# Supplementary Specification to API Standard 671 for Special-purpose Couplings

**NOTE** This version (S-700J) of the specification document provides the justification statements for each technical requirement, but is otherwise identical in content to S-700.

VERSION	DATE	PURPOSE
1.1	July 2023	Issued for Public Review
1.0	May 2020	First Edition

**Figure L.1—Coupling Direction of Rotation and Power Flow**

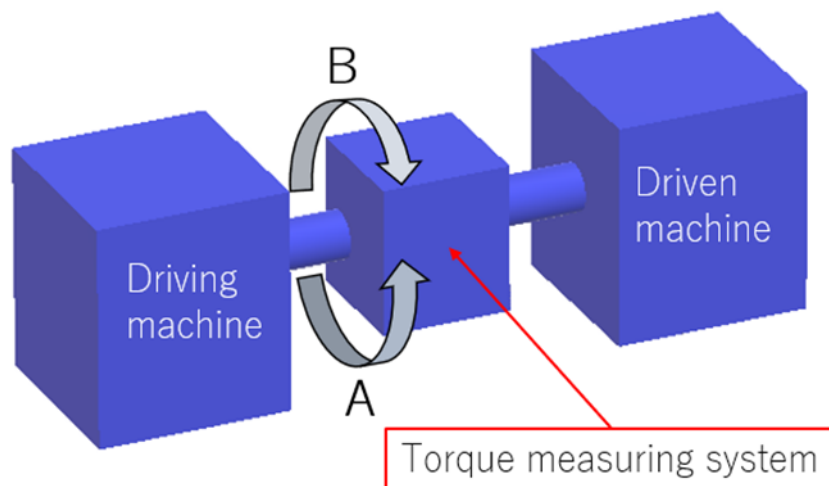
### Add to list item e)

in accordance with Figure L.1

### Add new Figure L.1

### **Justification**

*Figure L.1 provides a reference to allow the direction of rotation and power flow to be specified.*
